# 10-06-01-008M: Engine Oil Consumption on Aluminum Block/Iron Block Engines with Active Fuel Management (AFM) (Install AFM Oil Deflector and Clean Carbon from Cylinder and/or Install Updated Valve Cover) - (Nov 26, 2014)

Subject: Engine Oil Consumption on Aluminum Block/Iron Block Engines with Active Fuel Management (AFM) (Install AFM Oil Deflector and Clean Carbon from Cylinder and/or Install Updated Valve Cover)

This Bulletin has been revised to update Warranty Information. Please discard Corporate Bulletin Number 10-06-01-008L.

Aluminum or Cast Iron Block - Oil in Intake Manifold - Install Updated Valve Cover on All Models Built Prior to February 1, 2011

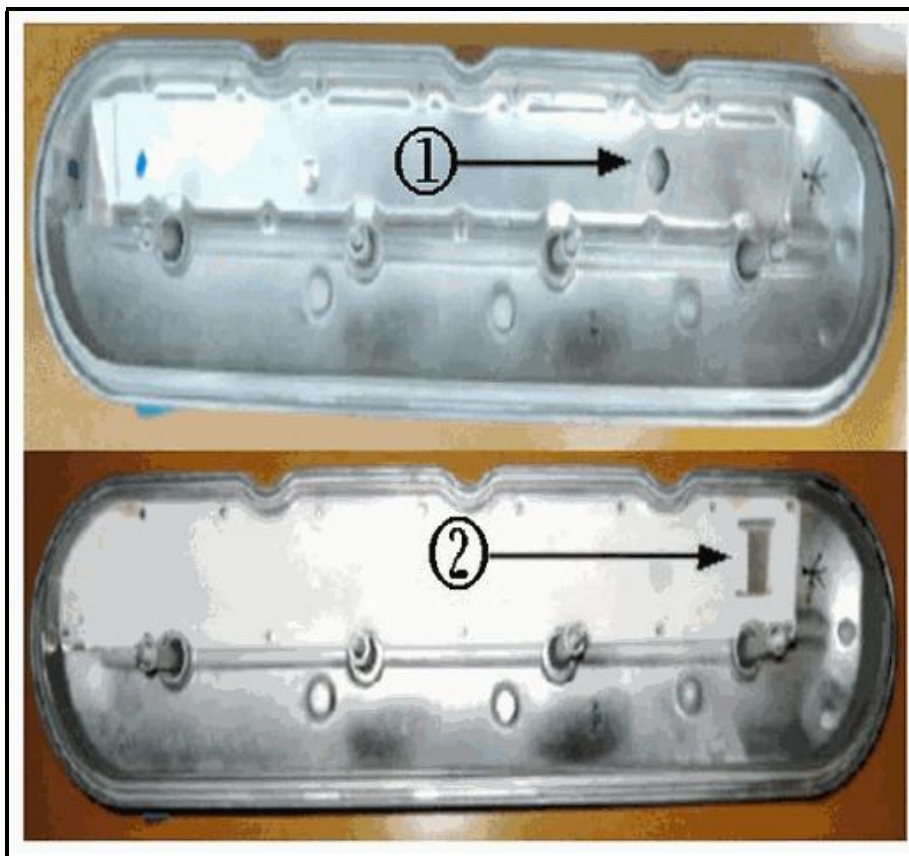
1) Old Design

2) New Design

PCV pullover or an overactive lifter can cause oil to be pulled through the PCV system even at low vehicle mileage. A correctly functioning PCV system will only leave a film of oil in the intake manifold. Inspect the intake manifold to see if there is any oil puddling in the bottom. If there is you will need to replace the left valve cover. Two new left rocker arm covers have been released for trucks and vans. Technicians should replace the left rocker arm cover with GMP/N 12570427 for 2007-2008 or GMP/N 12642655 for 2009-2011. Refer to the Parts Information below for the Camaro. This rocker arm cover has a relocated PCV drain hole that prevents oil from entering the intake manifold. Refer to Valve Rocker Arm Cover Replacement - Left Side in SI.

These rocker covers are for specific years. The PCV orifice is different for each. The correct cover must be used or an SES light may set.

When installing the updated valve cover or reinstalling a used valve cover, verify that the baffles can hold water and do not leak. If any leaks are found, seal with RTV if possible or replace the valve cover. Thoroughly clean and dry the valve cover before installation.

Aluminum Block - Oil Getting Past Piston Rings - Free Up Piston Rings and Install AFM Shield on All Non-Hybrid Models

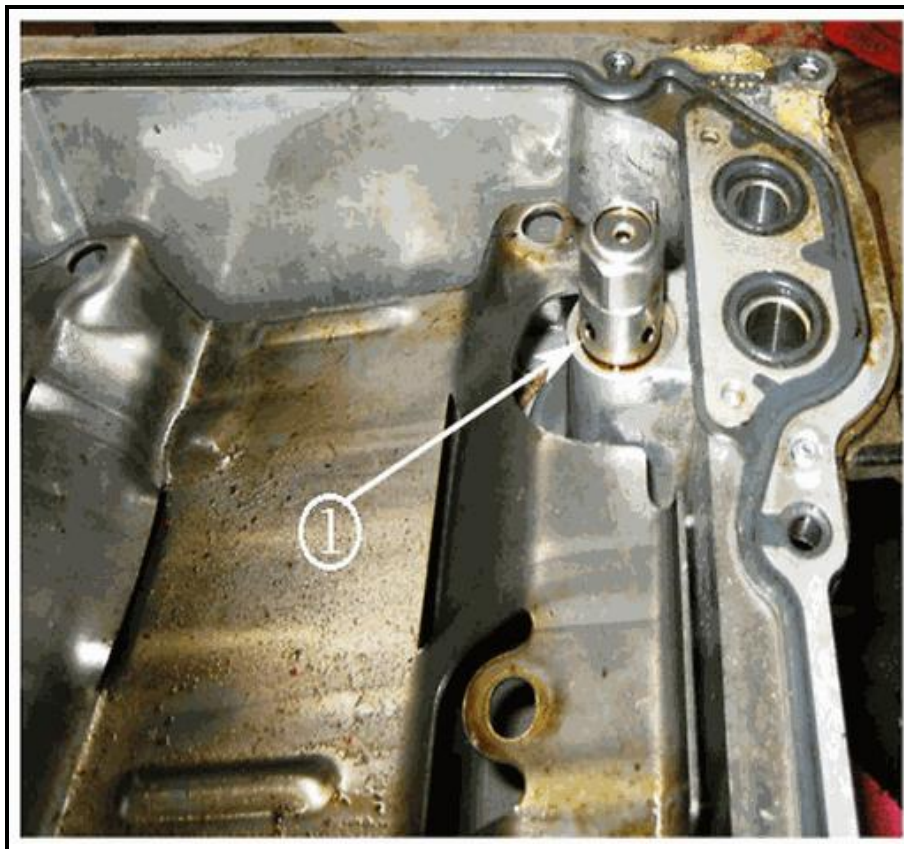
To correct this condition, install an AFM shield, perform the piston cleaning procedure as described in this document and install a new oil pan gasket per the procedure outlined in this document.

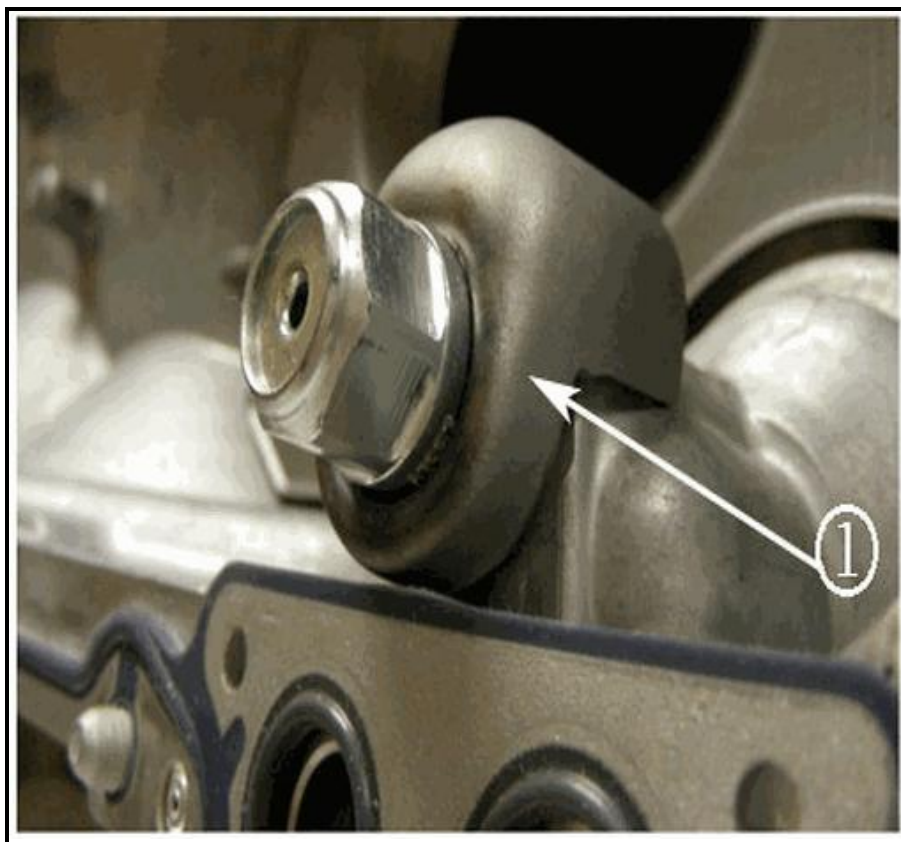
4. Remove the AFM valve (1).

5. Install the new shield (1), GMP/N 12639759, and tighten the AFM valve to the oil pan to 28 N.m (20 lb ft).
